Application No. 10/725,971
Amendment dated June 27, 2005
Reply to Office Action of February 25, 2005

Amendment To The Drawings:

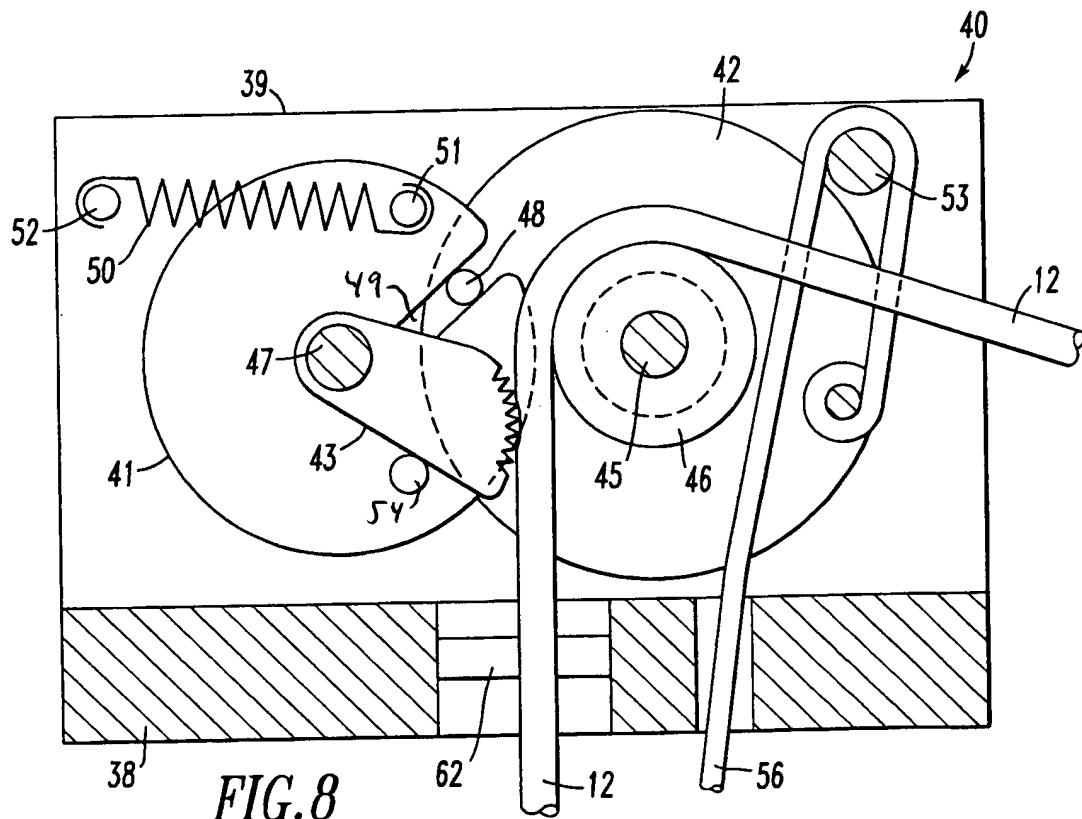
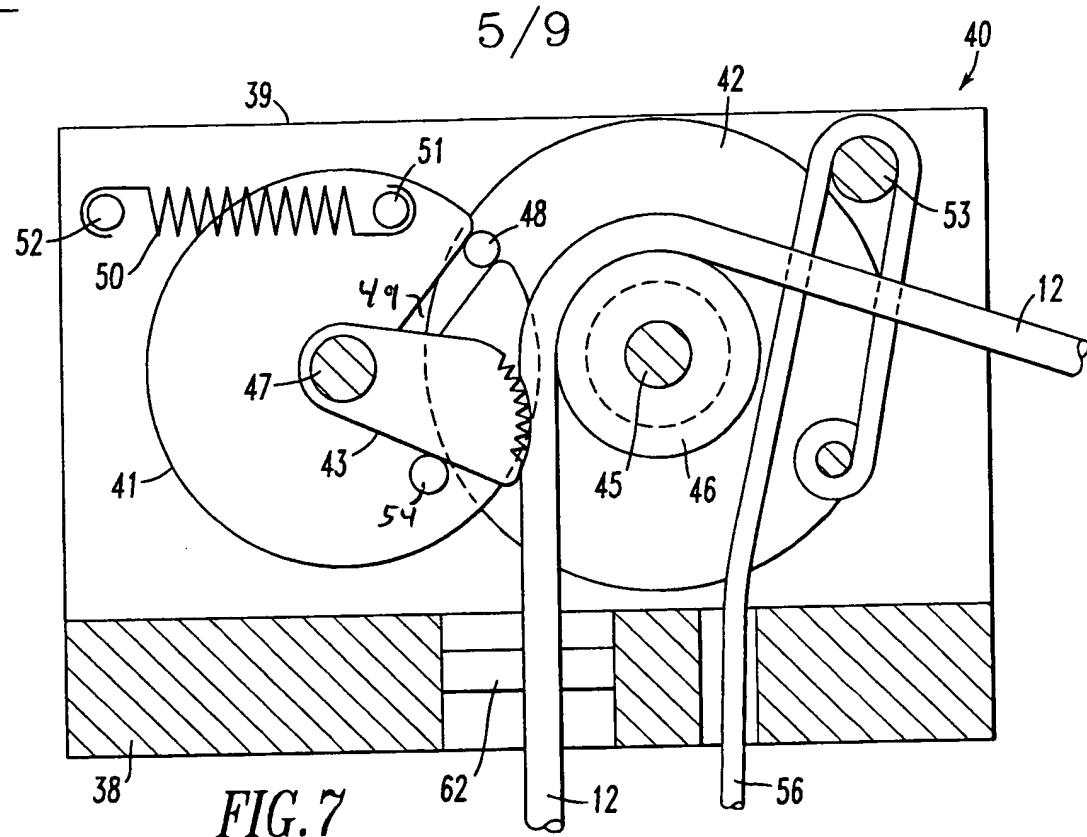
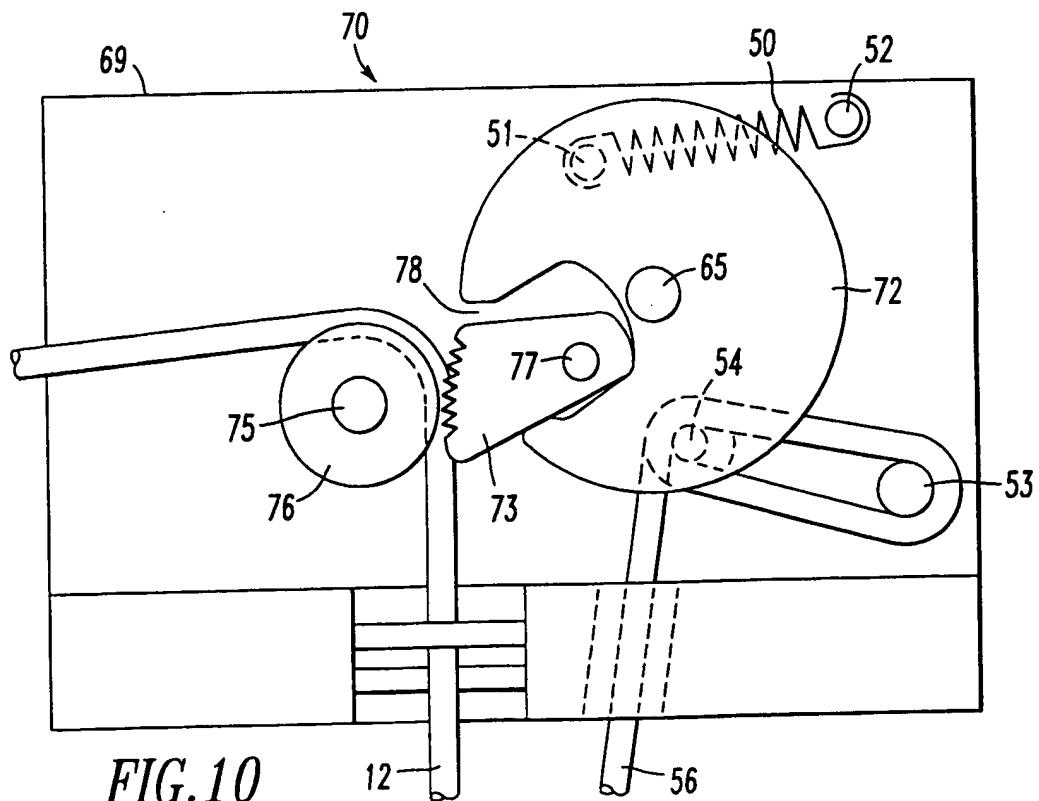
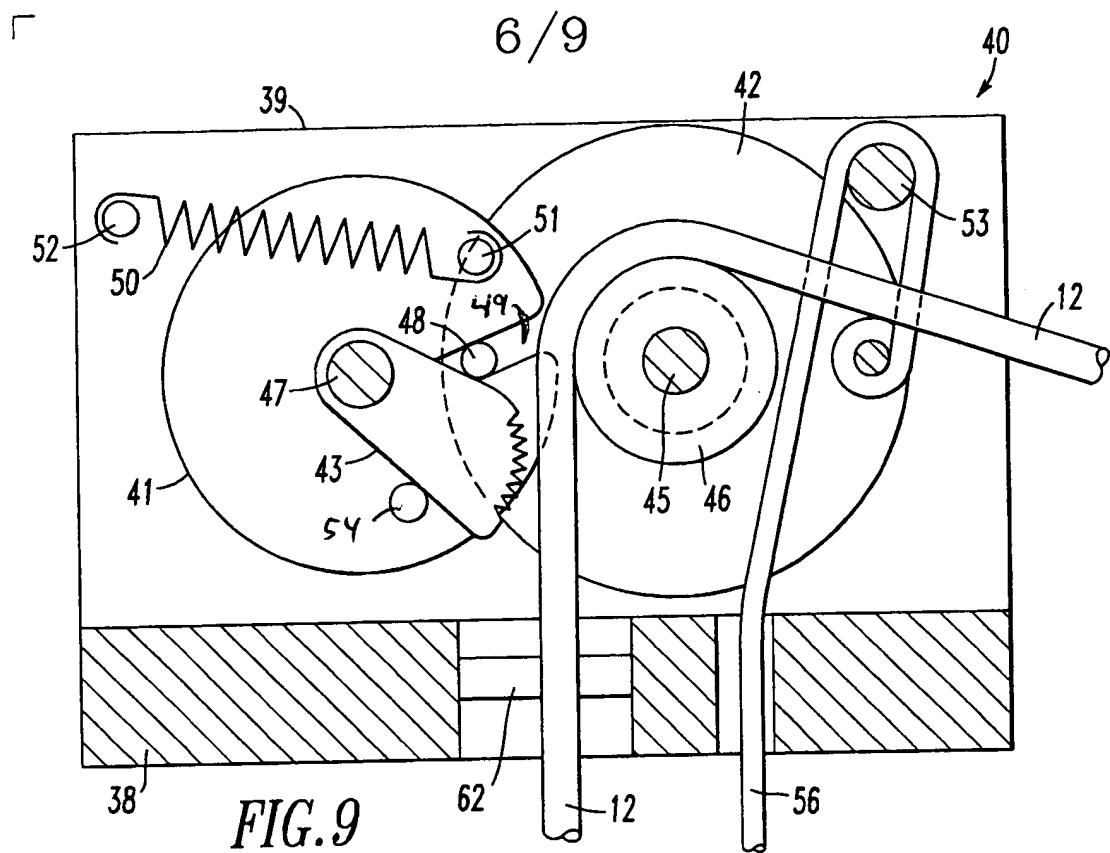
Applicants submit corrected drawing sheets 5, 6 and 7 containing Figures 7 through 12. Reference numbers 49 and 54 have been added to Figures 7, 8 and 9. This correction is made to overcome the Examiner's objection that reference number 49 does not appear in the drawings.

FIG. 11

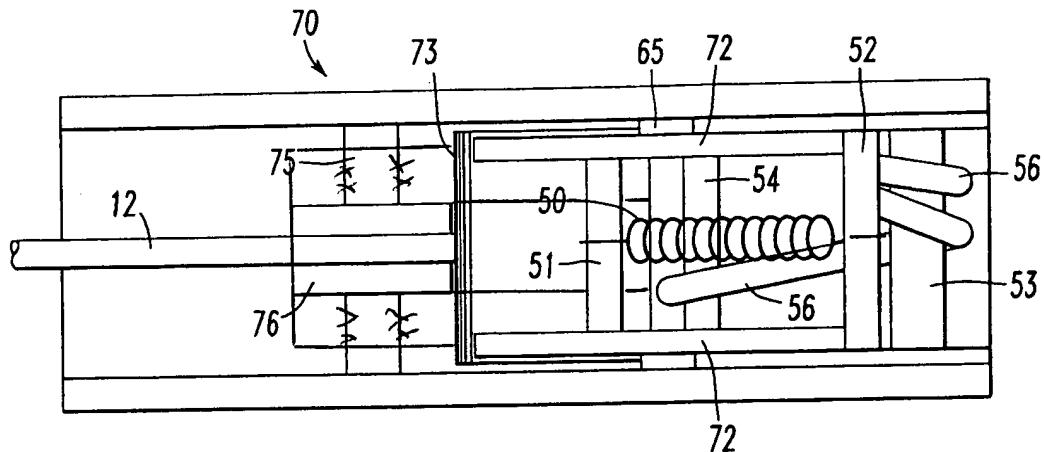
Applicants have also corrected Figure 11 to show multiple wheels 76 and cams 73. Support for this change is in the informal Figure 11 submitted with the application which shows multiple cams 73. It should be noted that the cams in original Figure 11 are inverted making the figure inconsistent with original Figure 10. At page 9, line 17 says "cams 73" clearly indicating that the embodiment contains more than one cam. Corrected Figure 11 is consistent with Figure 10.
